City of Linden
Union County, New Jersey
Department of Community Services
Division of Engineering
301 North Wood Avenue
Linden, New Jersey 07036
Phone: 908-474-8470
Fax: 908-486-0725
E-mail: engineering@linden-nj.org

October 8, 2020

Re: *Application No. SP 1132-20*
Linden Development LLC
Amended Preliminary & Final Major Site Plan
Proposed Medical/Professional Office Building
Portion of Block 469 Lot 38.05
1016 West Edgar Road, Linden, NJ

DETAIL OF CONCRETE SIDEWALK

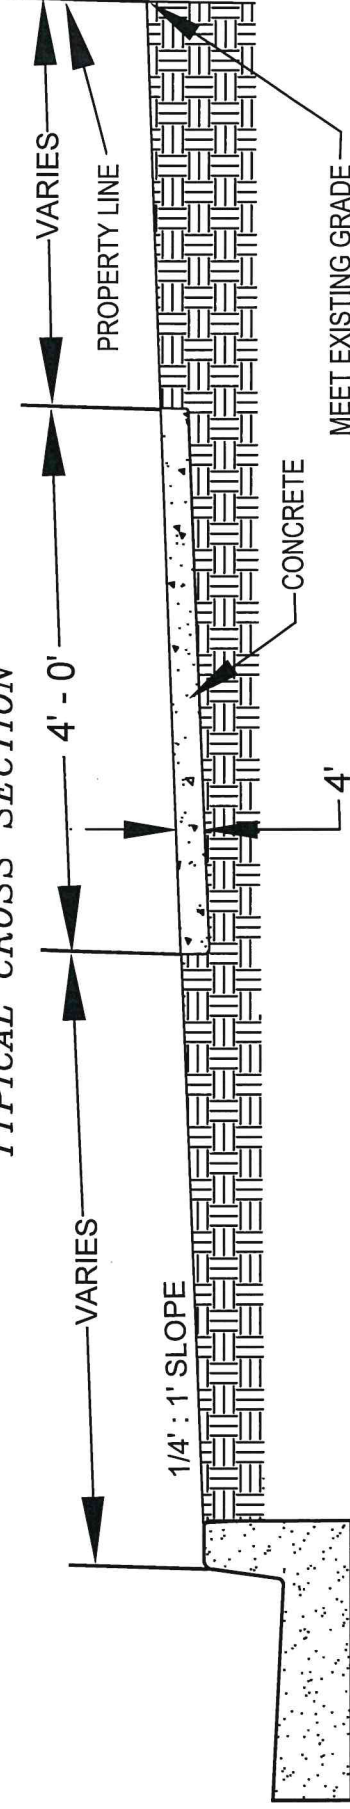
- Transverse joints ½" wide shall be 10 ft. apart in the curb and 12 ft. apart in the sidewalks. Construction details for proposed Sidewalk shall be added on the drawings;

- Concrete Sidewalks;
 - Vertical Concrete Curb;
 - Curb and Sidewalk Joints;

- (6) A FULL DEPTH TRANSVERSE EXPANSION JOINT IS TO BE CUT EVERY 12 LINEAR FEET. JOINTS SHALL BE FILLED WITH PREFORMED EXPANSION JOINT FILLER, 1/2 INCH THICK, WHICH SHALL BE FLUSH WITH THE TOP. A FALSE TRANSVERSE JOINT IS TO BE CUT EVERY 4 LINEAR FEET.
